Groundwater Application Review Summary Form

Application # G- 18518

TO: Water Rights Section Date 12/04/2017
 FROM: Groundwater Section Phillip I Marcy
 Reviewer's Name
 SUBJECT: Application G- 18518 Supersedes review of _____
 Date of Review(s)

A. GENERAL INFORMATION: Applicant's Name: Polehn Heights Water Association Inc. County: Clackamas

Water-Level Trends in Nearby Wells

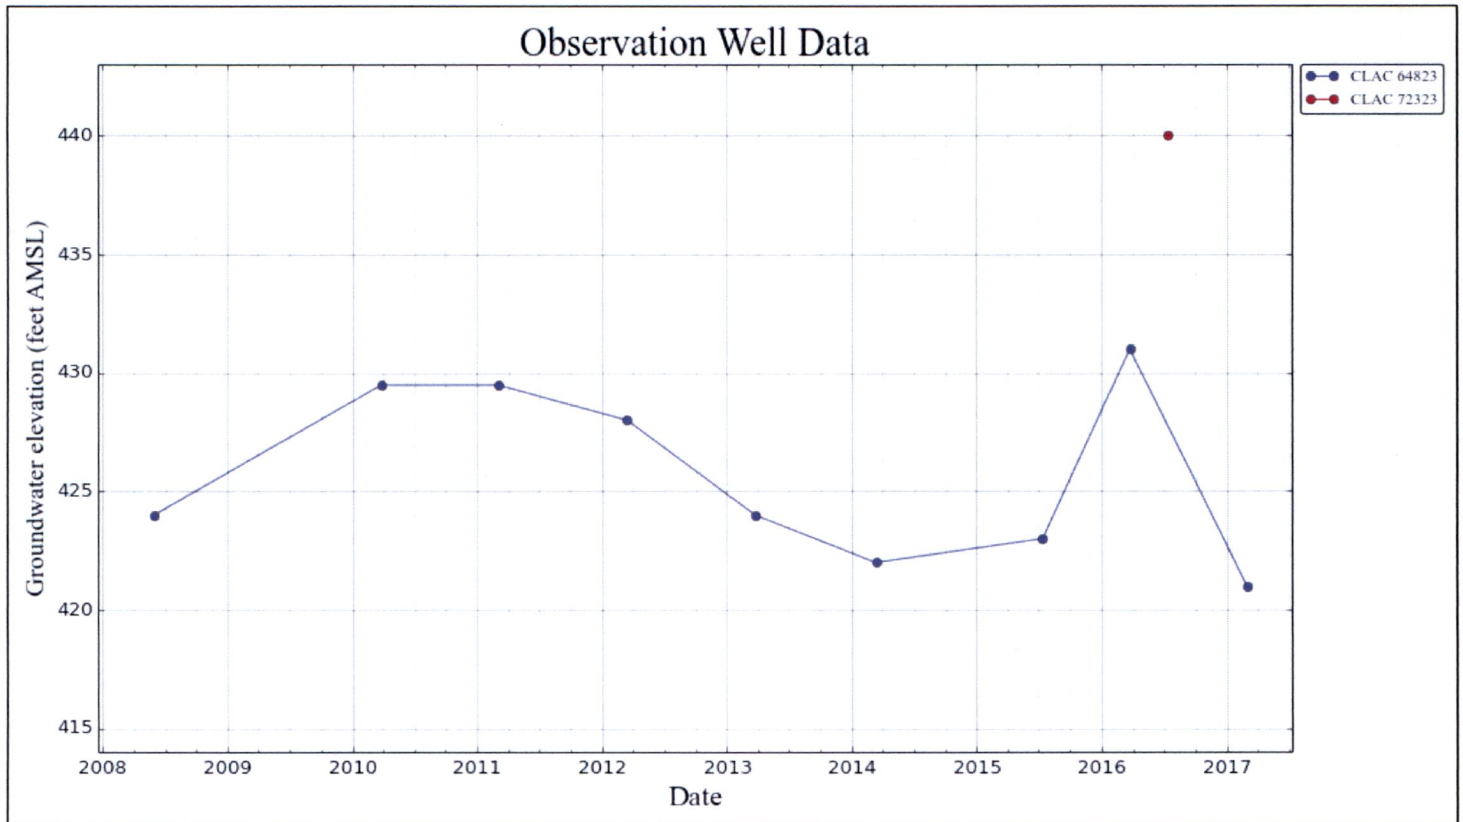
B3. **Groundwater availability remarks:** The area in the vicinity of the proposed POA well is underlain by basalt flows of the Boring Lavas and sediments of the Troutdale Formation and the Sandy River Mudstone (Trimble, 1963). In the area of the applicant’s well, basalt flows of the Boring Lavas occur at land surface (Trimble, 1963). The basalt flows are generally up to 200 feet thick in the area, except in areas near the eruption vents, where the basalts extend to much greater depths. A few wells in the area report Boring Lavas to depths of about 550 feet (see logs for CLAC 61545 and CLAC 61546). Beneath the Boring lava lies several hundred feet of older alluvium, which is generally fine-grained mudstone containing beds of sand and gravel. The proposed POA (CLAC 72323) produces from a sand and gravel aquifer beneath a significant thickness of Boring Volcanics. Similar lithology is reported on nearby log CLAC 64823, which is located roughly 0.8 miles to the NW of the proposed POA location and also constructed to produce from water-bearing gravels beneath greater than 100’ of basalt. These wells report similar water level elevations, which are fairly stable in CLAC 64823, fluctuating roughly 10 feet since 2008 (see attached hydrograph).

Nearby CLAC 64823 (0.8 miles away) displays reasonably stable water levels during the past decade. Groundwater elevation is nearly coincident with that reported in POA well CLAC 72323.
